TOLEDO-LUCAS COUNTY PLAN COMMISSIONS

REF: SUP-11001-17

SUBJECT: Special Use Permit for a Medical Marijuana Dispensary

Location - 3151 - 3157 West Sylvania Avenue

SITE PLAN

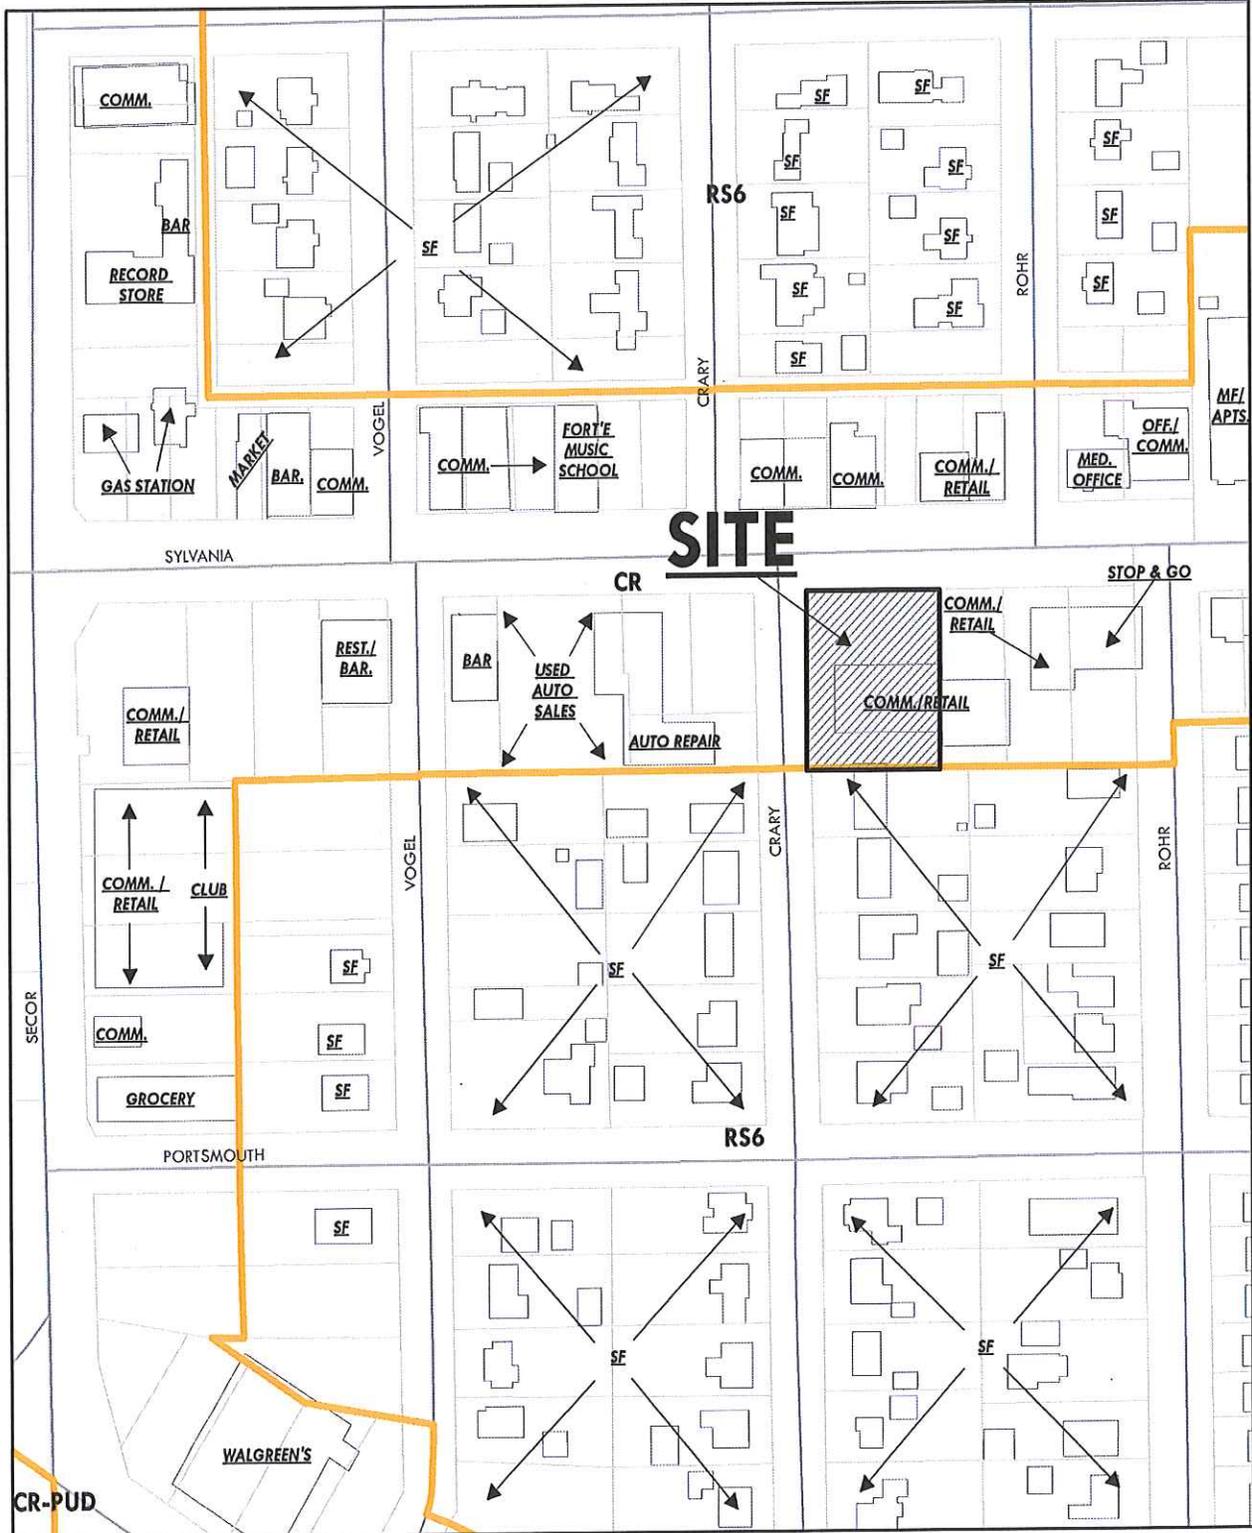
Currently there are six (6) parking spaces that are perpendicular to the building and accessed via an unimproved curb cut along Crary Drive. The site plan depicts improvements to this area that include landscaping upgrades, the removal of the six (6) existing parking spaces, the addition of two (2) parking spaces parallel to the building, and a place dedicated to bicycle parking. It is recommended that this area be dedicated solely to landscaping. The two (2) parallel parking spaces are not needed and the bicycle parking can be relocated elsewhere on site.

The applicant is required to provide at least two (2) accessible parking spaces for persons with physical disabilities. The site plan submitted depicts one (1) accessible parking space close to the entrance but is not in compliance with the required number of ADA parking spaces (unless the two (2) parking spaces on the west side of the building are removed). Additionally, the minimum number of bicycle parking spaces for the proposed dispensary is one (1) slot per ten (10) parking spaces. The site plan submitted depicts three (3) bicycle parking spaces and is in compliance with parking schedule "A". As mentioned earlier, the bicycle parking will need to be relocated elsewhere on the site.

The site was established before the 2004 zoning code update and therefore not required to fully comply with the landscape requirements. Per TMC§1114.0502, the site is required to be brought closer into compliance with the 2004 zoning code. There is adequate space for at least a ten (10') foot greenbelt along the Sylvania Avenue frontage and a fifteen (15') foot greenbelt along the Crary Drive frontage. These greenbelts must be on the applicant's property and not in the right-of-way as currently depicted. A revised landscape plan shall be submitted showing compliance.

The greenbelt shall include at least one (1) tree every thirty-feet (30') of lot frontage. Calculations conclude that a total of four (4) trees are required in the frontage greenbelt along West Sylvania Avenue and a total of five (5) trees are required along Crary Drive. Additionally, since the parking lot is visible from the right-of-way, the frontage greenbelt shall include a solid hedge or shrub row along West Sylvania Avenue in order to screen the parking lot and ensure that headlights do not project onto the public street. These plantings must be on the applicant's property and not in the right-of-way as currently depicted. A revised landscape plan shall be submitted showing compliance.

A Type A landscape buffer is required to be provided along the south side of the property that abuts residential zoning. Said buffer shall consist of ten (10') foot wide of landscaping located inside of a solid wood fence. The applicant is proposing a six (6') foot high chain link fence with privacy slats with no landscaping. This is not an acceptable fence material. A landscape plan shall be submitted that shows compliance with the Toledo Municipal Zoning Code.

19. All lots of the development site shall be combined into a single taxable parcel identification number.
20. Bicycle parking slots shall be provided pursuant to Off-Street Parking Schedule "A" (TMC§1107.0300). Off-Street Parking Schedule "A" requires one (1) bicycle parking slot per ten (10) parking spaces. **(Location not acceptable as depicted on site plan).**

- b. A continuous hedge or shrub row, a minimum height of eighteen-inches (18") and maximum of forty-two inches (42"), shall be installed along West Sylvania Avenue in order to screen the parking lot and headlights from public view. **(Location not acceptable as depicted on site plan).**

16. The area depicting two (2) parallel parking spaces and bicycle parking shall be dedicated solely to landscaping and the bicycle parking shall be relocated to another area on site. A revised site plan shall be submitted indicating compliance with this requirement.

- a. A five (5') to ten (10') wide frontage greenbelt shall be provided along Sylvania Avenue and a fifteen (15') foot frontage greenbelt along Crary Drive, both outside the right-of-way and with one (1) tree for every thirty-foot (30') of frontage. Calculations conclude that a total of four (4) trees are required in the frontage greenbelt along West Sylvania Avenue and five (5) trees along Crary Drive. **(Approval is subject dependant on a revised survey).**

- h. The location, height and materials for any fencing to be installed and maintained. A screening buffer shall be added along the south property line and shall consist of ten (10') foot wide of landscaping located inside of a solid wood board on board fence. **(All new fencing shall conform to the accessory use standards of TMC§1105.0302);** and
